Summary of Items Discussed in APSEC Discussion Forum (ADF) 2/2025 on 9 May 2025

THE TOPMOST FLOOR OF THE MOE STAIRCASE
(ONE DIRECTION)

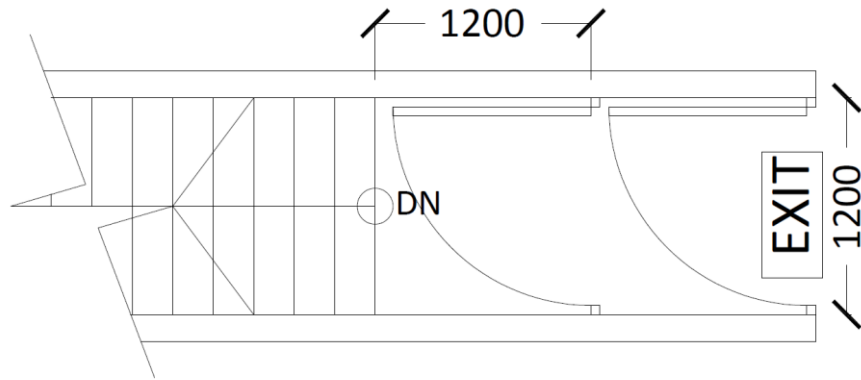
11.	<p><u>Exit Door and Landing in Required Staircase on Topmost Floor</u></p> <p>Further to item 13 of ADF 4/2012 on 3 August 2012 regarding Clauses B13.3 and B14.3 of the FS Code, for the topmost floor being served by a required staircase, the arrangement being shown in the diagram below shall be able to comply with the requirement in Clause B13.3 of the FS Code as that landing is not situating between flights and the door swing shall not be deemed as reducing the effective width of the exit route. Please confirm whether our understanding is correct or not.</p>	BD advised that HKIS's understanding was correct.

Scenario 1 – Adjoining Site located partly between Street and subject Site:

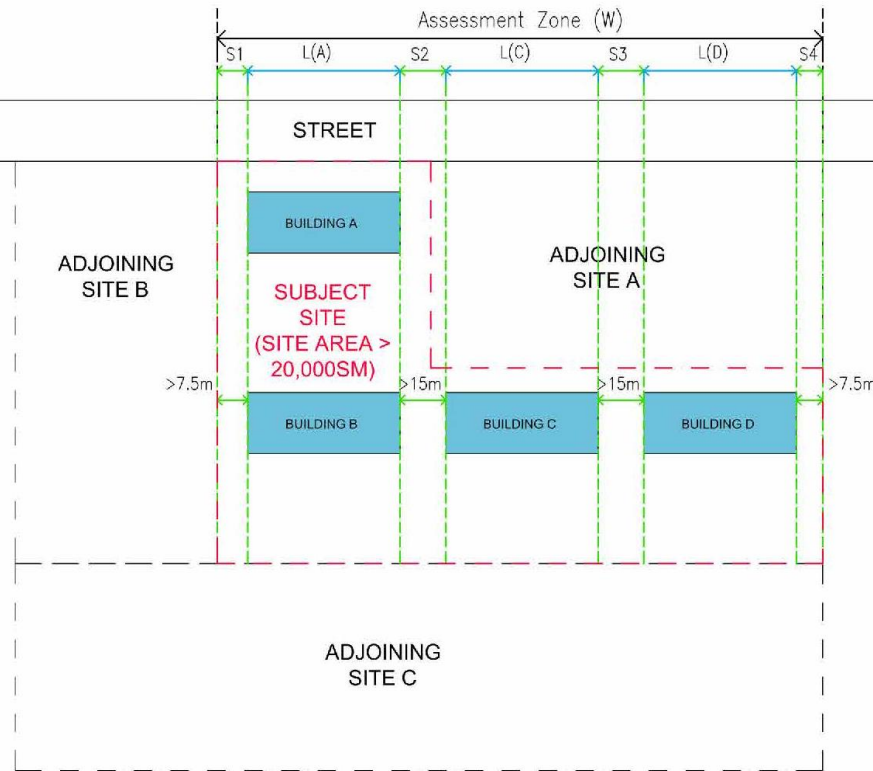
13.	<p><u>Building Separation – Design Requirement (2) – Separating Distance (S) and Permeability (P)</u></p> <p>In accordance with paragraph 3.1 of Appendix B to PNAP APP-152, “<i>at least one of the projection planes for the low zone shall be set parallel to a street on which the site abuts</i>”. Please advise if our understandings on the projection plane and assessment of <i>S</i> and <i>P</i> for low zone as illustrated in the below scenarios are correct:</p>	<p>BD advised that the purpose of building separation was to improve air ventilation, enhance environmental quality at pedestrian level and mitigate heat island effect arising from the undesirable walling effect of “long buildings”. According to Appendix B to PNAP APP-152, for building proposal with a site area not less than 20,000m², the assessment on compliance with Design Requirement (2) shall be made through a pair of vertical projection planes at an orthogonal relationship to each other. At least one of the projection planes for the low zone shall be set parallel to a street on which the site abuts and must be projected onto the street side. Item 1 of ADF 1/2014 was relevant.</p> <p>The separating distance involving site boundary or adjoining street/lane,</p>

if it varies on plan, should comply with the requirements under paragraph 4.2 of Appendix B to PNAP APP-152.

Nullah zoned as open space under OZP might be treated as a lane for the purpose of assessing separating distance and permeability.

If the building proposal could not meet the prescriptive requirements under Appendix B of PNAP APP-152, alternative approaches provided in Appendix E to PNAP APP-152 could be adopted. The building separation requirement at the low zone may be waived for buildings with less dominating building bulk and adequate setback along street frontage.

The adoption of performance-based design alternative on the provision of building separation might also be accepted. AP, RSE and RGE might make use of the pre-submission enquiry mechanism for early clearance of basic design principles so that they could proceed with confidence in the formal submission stage.

17. **Common Secondary Exit Door for Two Adjoining Rooms**

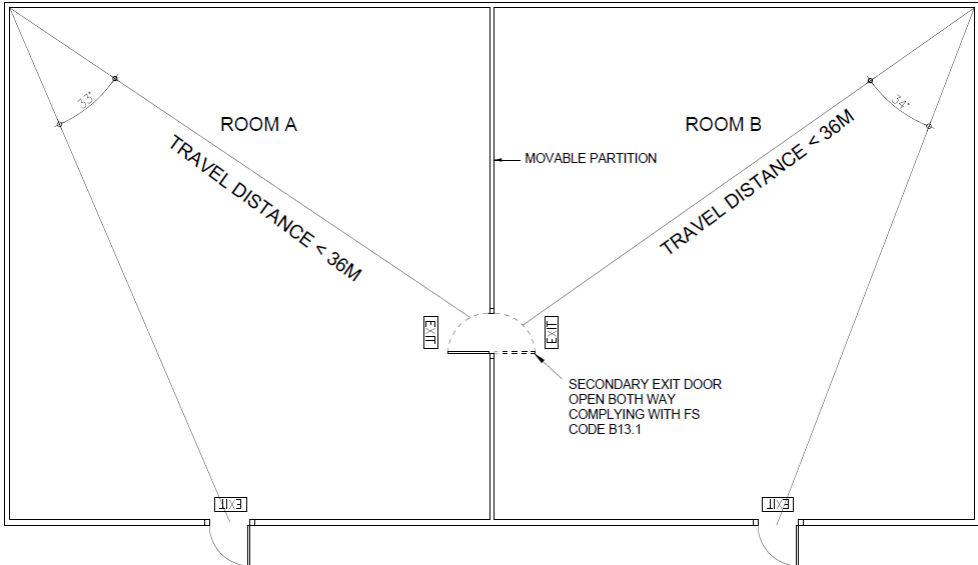
Referring to the below drawings, the exit door opened both ways complying with Clause B13.1 of the FS Code serves as the common secondary exit door for two adjoining rooms. Would BD advise that it is acceptable given that requirements of travel distance could be fulfilled?

BD advised that additional information including the travel distance between the furthest point on a storey or within a fire compartment to the centre of the fire rated door to a protected exit or a required staircase, the Use Classifications and occupancies of Room A and Room B, etc. should be clarified for further consideration on whether the scenario in the diagram was acceptable.

Without prejudice to the above, provided that the requirements on travel distance were complied with, and Room A and Room B were not required to be separated from each other by fire barriers, the said common exit door which opened both ways and had a transparent upper view panel would be accepted as a secondary exit door of both rooms under the FS Code.

18. **Requirement on Fire Resistance Rating (FRR) for Supporting Frame for Raised Reinforced Concrete (RC) Floor Platform**

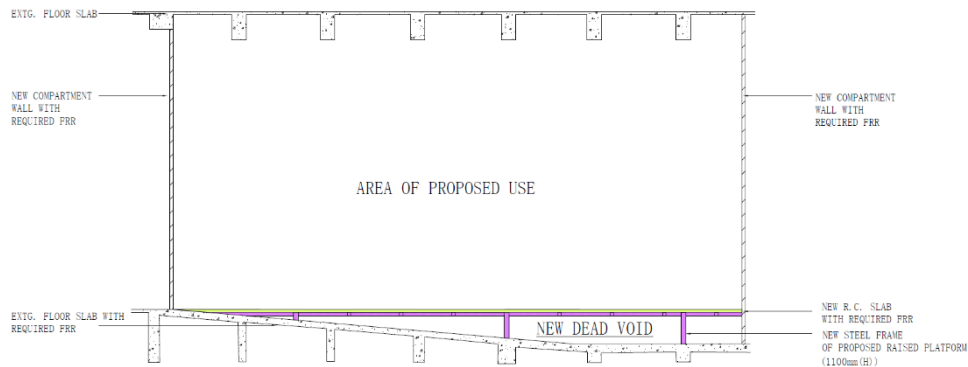
In an A&A submission, a new raised RC floor platform is proposed. It will be sitting on an existing floor slab to create a level surface for meeting the functional requirement of the proposed space as well as facilitating the barrier free access. A “dead void” with no use or access would therefore be formed under the proposed platform as shown in the diagram below.

The dead void will be fully enclosed by fire barriers with the required FRR (e.g. RC slab, Y-tong block wall, fire rated gypsum plaster board, etc.) from all directions.

As the dead void itself would not pose any fire risk and the exposed surfaces of the steel frame inside the dead void could be fully protected by the said fire barriers, the steel frame in the dead void shall not require any further fire rated intumescent coating or sprayed-applied cementitious fire coating.

Please clarify if our understanding is correct or not.

BD advised that pursuant to “Section 3 – Definitions” in Part A of the FS Code, any raised flooring system at a height of more than 600 mm from the original floor would be considered as an element of construction. As such, the proposed raised RC floor platform of 1100 mm high as shown in the diagram was regarded as an element of construction and should be provided with the requisite FRR under Clauses 4.1 and 4.2 of the FS Code.

[**Post-meeting note:** In consultation with FSD, BD advised that non-provision of fire resisting coating to the steel members inside the inaccessible void (i.e. dead void) of the proposed raised flooring system would be favourably considered.]
